SUBJECT: 42 Mellen Street

## BUILDING PERMIT REPORT

DATE: 3/19/58 ADDRESS: 42 Miller St
REASON FOR PERMIT: Erect Fice CIC. P.
BUILDING OWNER: 3.66.TT
CONTRACTOR: Ray Mary MI
PERMIT APPLICANT: hinds Bib. IT
USE GROUP R2 BOCA 1996 CONSTRUCTION TYPE 5 B
CONDITION(S) OF APPROVAL
This Permit is being issued with the understanding that the following conditions are met:
Approved with the following conditions: $\frac{1}{2}$
This permit does not excuse the applicant from meeting applicable State and Federal rules and laws.
<ol> <li>Before concrete for foundation is placed, approvals from the Development Review Coordinator and Inspection Services must be obtained. (A 24 hour notice is required prior to inspection)</li> </ol>

STRUCTURE EXSISTING SIDIT VIEW THE CANDON STANDS FIRE ESCAPE AMENNED VIEW GOTTER 42 MELLENST. +WETER! PROJECTION OF SNOW NPR - 1 1998 MANGARD , GOTTED DLAT FORTY

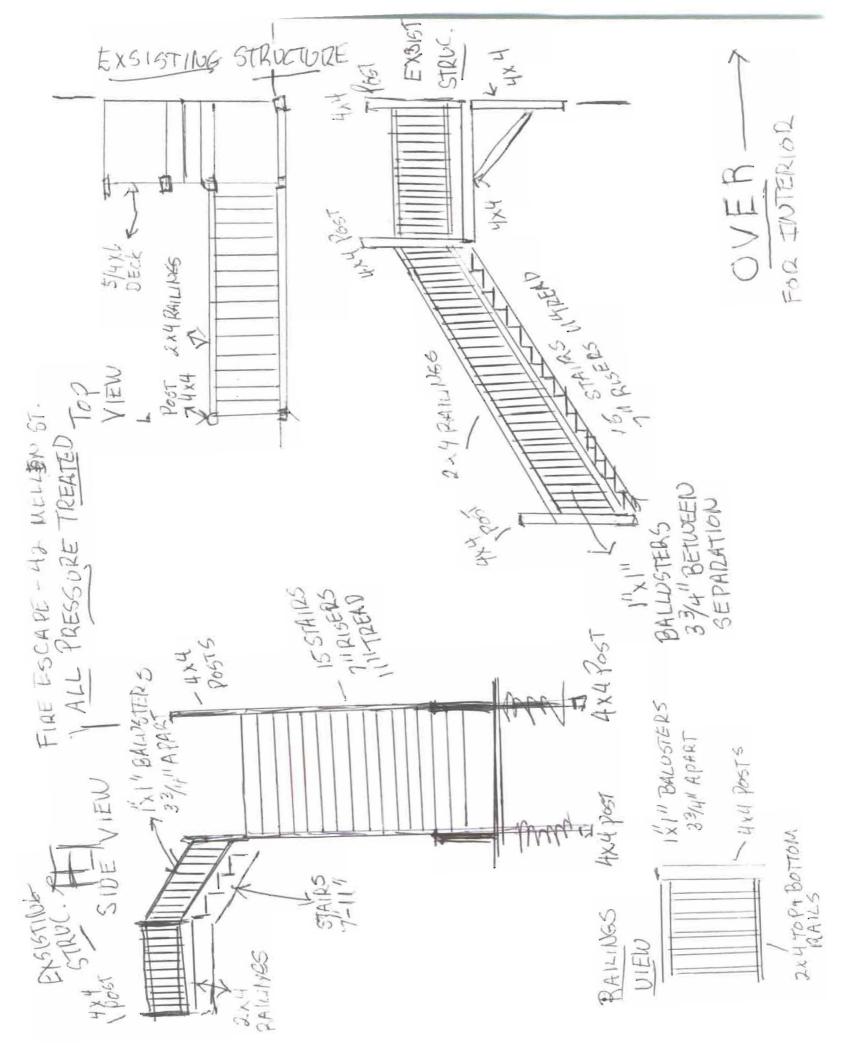
Due to the need of a legal apartment with proper egress, I am requesting that the proposed fire escape not be required to protect this stair system with a roof canopy design. Both platforms are semi-protected and the construction of a roof over the stairs would detract from the historic qualities of the structure.

MY NAME IS EDWARD BABBITI OF 42 MELLEW ST. IN REGARDS to My Fire Escape to be built on the premises to allow fine eggress from Apt ZFROWT AND Apt Z READ. To cover the platforms and structure with a caropy would be of great detriment to the buildings tistoric balve and to the city of PORTLHIOD. As described in amended view Platforni#1 will and does have an exsisting canopy from the exsisting overhand, PLATFORM #z from which there is a small window of blew from MELLEW ST. is approx, one third covered with overhang and a mansard projection with gutters to eliminate a huge amount of show and ice. I have a person on site whom I pay all winter to shovel, sand and Salt, supply all materials needed and personally inspet from storm to Storm. My other concern as I am Sure yours, 15 the Safety of any tenants or firemen who would need to use this structure and the Sooner it is completed the best for everyone envolved. I have read section 1025. I and interpret that as being trept free of ice and snow or why elsewould it say "Applied as often as neccessary." I hope this matter can be settled as quickly as possible and without any litogations
